# **Camden Residents' Action Group** Incorporated Camden – Still a Country Town

## RE: DA 2018/775/1 18 - 20 Broughton Street, Camden

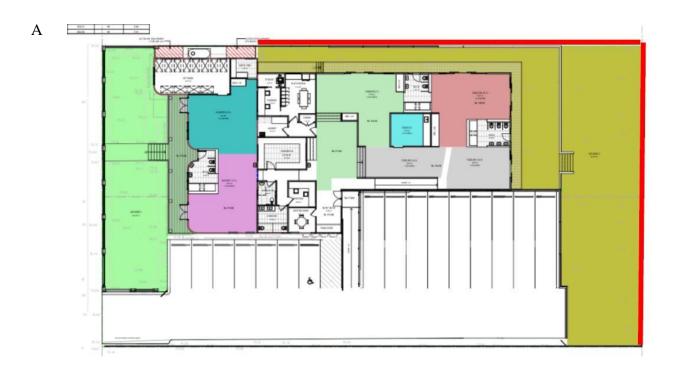
Perhaps the diagram below is deceptive but the outdoor play area seems small for potentially 99 children. All else being equal it would seem that the smallness of the play areas at the front and rear of the property would contribute to more intense noise.

As shown in red in the above diagram a 2.1m solid continuous barrier is recommended to be constructed to the boundary of the proposed rear external play area to mitigate noise (SEE, p. 55).

Concern has been expressed that the barrier in the above diagram may not be high enough to screen noise especially for residential neighbours, including in Park Street.
